Access Compliance Report

Public Rights-of-Way

(Curb Ramps)

Intersection ID: 46742	Main Street: HAMILTON_RD	Cross Street: CUMBERLAND_COVE_DR	Location: NE
ADA ID: 17EF6C3A3D33	Ramp Type: PerpDiag	Initial Pass/Fail: Fail	Overall Compliance: No
		Severity Score: 10

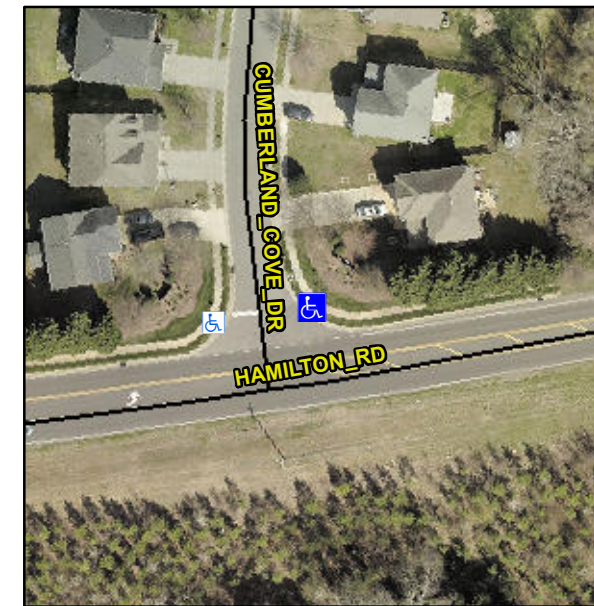
Not Found, R304.5.1, R304.5.3

Compliance	Description	Data	Compliance	Description	Data
N/A	Ramp Length (in)	48.0	Yes	Ramp Slope (%)	6.8
No	Ramp Width (in)	47.0	No	Ramp XSlope (%)	3.6
N/A	Flare Type LT	N/A	N/A	Flare Type RT	N/A
N/A	Flare Slope LT (%)	N/A	N/A	Flare Slope RT (%)	N/A
N/A	Flare Traversable LT?	N/A	N/A	Flare Traversable RT?	N/A
N/A	Landing Length (in)	N/A	N/A	DWS Provided?	N/A
N/A	Landing Width (in)	N/A	N/A	DWS Contrast?	N/A
N/A	Landing Slope (%)	N/A	N/A	DWS Length (in)	N/A
N/A	Landing X Slope (%)	N/A	N/A	DWS Full Width?	N/A
N/A	Landing Curb? (Y/N)	N/A	N/A	DWS Offset (in)	N/A
N/A	Shared Landing?	N/A			
N/A	Gutter Ponding?	N/A	N/A	Gutter Slope (%)	N/A
N/A	Gutter Lip Ht (in)	N/A	N/A	Gutter X Slope (%)	N/A
N/A	Painted X Walk1?	No	N/A	Painted X Walk2?	No
	X Walk 1 Direction	To W		X Walk 2 Direction	To S
N/A	X Walk 1 Width (in)	N/A	N/A	X Walk 2 Width (in)	N/A
	X Walk 1 Slope (%)	2.3		X Walk 2 Slope (%)	0.7
	X Walk 1 X Slope (%)	1.2		X Walk 2 X Slope (%)	2.9

Remove & Replace Curb Ramp With Two New Directional Ramps or Equivalent.
